CP-200800057
Log # TXX-08008

SUBJECT: COMANCHE PEAK STEAM ELECTRIC STATION
DOCKET NOS. 50-445 AND 50-446
SUPPLEMENT TO LICENSE AMENDMENT REQUEST (LAR) 07-004
REVISION TO THE OPERATING LICENSE AND TECHNICAL SPECIFICATION 1.0,
"USE AND APPLICATION" TO REVISE RATED THERMAL POWER FROM 3458 MWT
TO 3612 MWT
(TAC NOS. MD6615 AND MD6616)

RESPONSE TO REQUEST FOR ADDITIONAL INFORMATION

Figure 2.8.5.4.2-26 Bank Withdrawal at Power – Unit 2, Maximum Reactivity Feedback – 100% Power – 1 pcm/sec - Pressurizer Pressure and Water Volume Versus Time

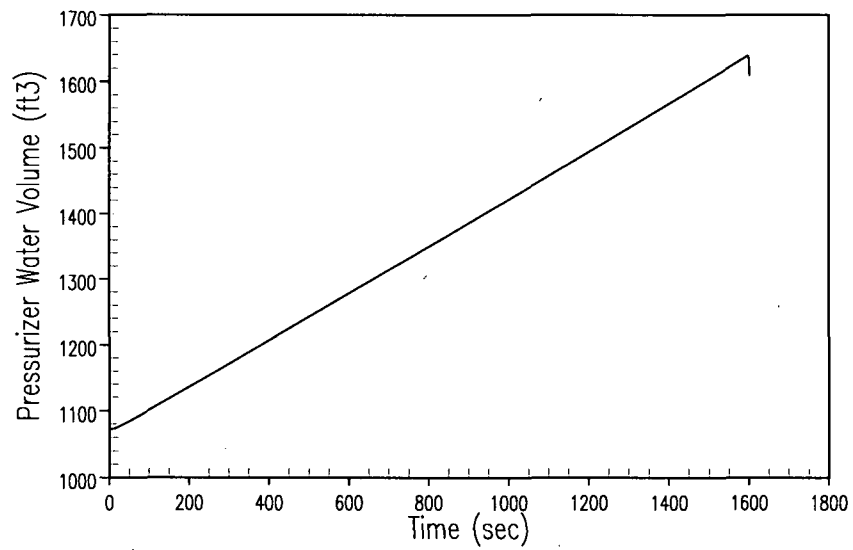
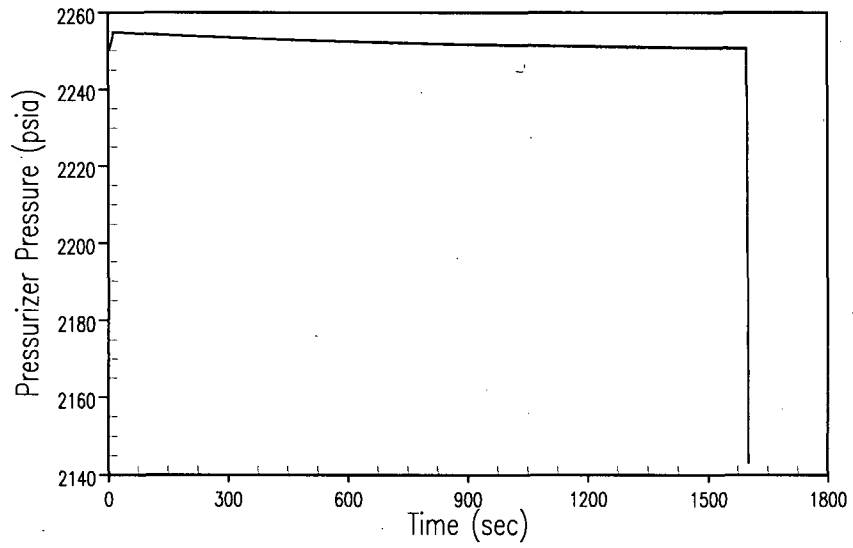
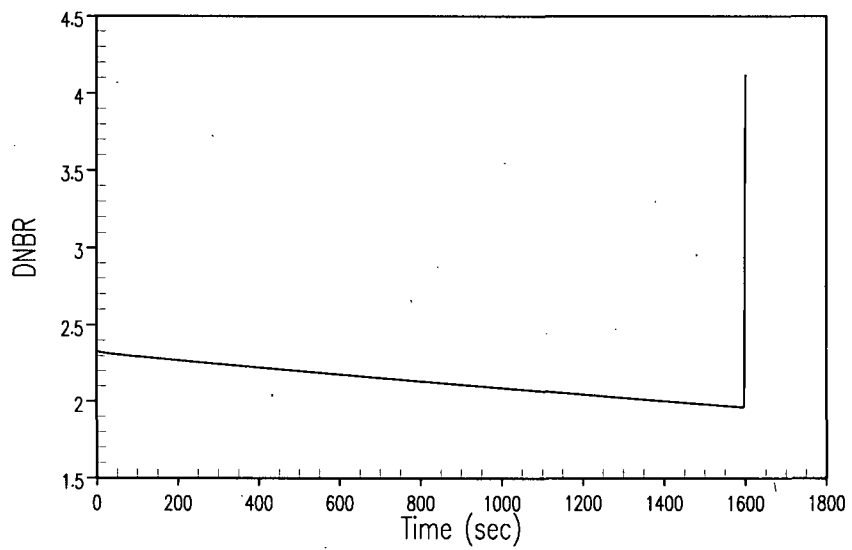
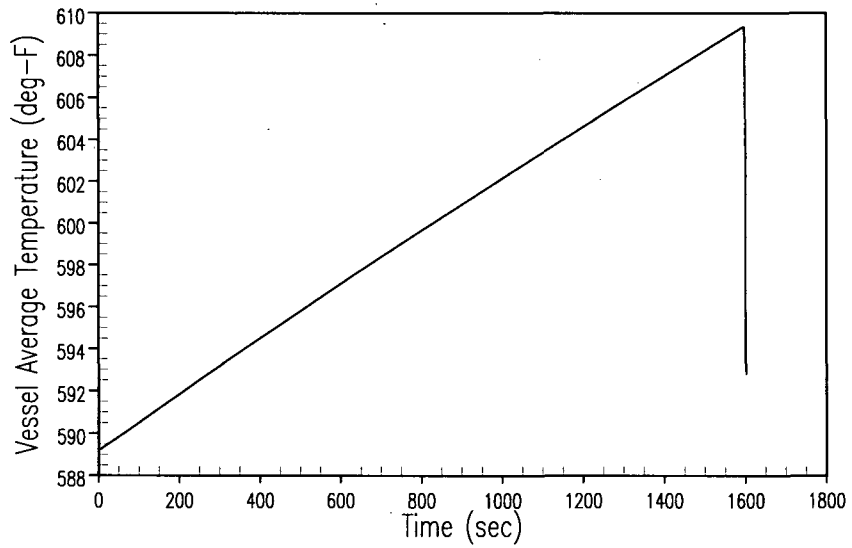
The SPULR states that two cases for minimum and maximum reactivity feedback were analyzed. The staff was unable to locate the results for the maximum reactivity feedback case. Provide these results.

The requested results are provided in the attached revision to Section 2.8.5.4.2 (Uncontrolled Rod Cluster Control Assembly Bank Withdrawal at Power). This section was recently revised to address some isolated issues related to the corresponding analysis. As the revised analysis affected results that were presented in Table 2.8.5.0-1, Table 2.8.5.4.2-1, and Table 2.8.5.4.5-1 (Boron Dilution) of the licensing report, revised tables are also provided (See Attachments 2 and 3).

Figures 2.8.5.4.2-7 through 2.8.5.4.2-9 (Unit 1) and Figures 2.8.5.4.2-22 through Figures 2.8.5.4.2-24 for (Unit 2) show the transient response for a rapid uncontrolled RCCA bank withdrawal incident (110 pcm/sec) starting from 100 percent power with maximum reactivity feedback. The transient response for a slow uncontrolled RCCA bank withdrawal (1 pcm/sec) from 100 percent power with maximum feedback is shown in Figures 2.8.5.4.2-10 through 2.8.5.4.2-12 (Unit 1) and Figures 2.8.5.4.2-25 through 2.8.5.4.2-27 (Unit 2). The results are similar to the results of the cases with minimum reactivity feedback, but the maximum reactivity feedback leads to a slower increase in power, resulting in a longer transient.
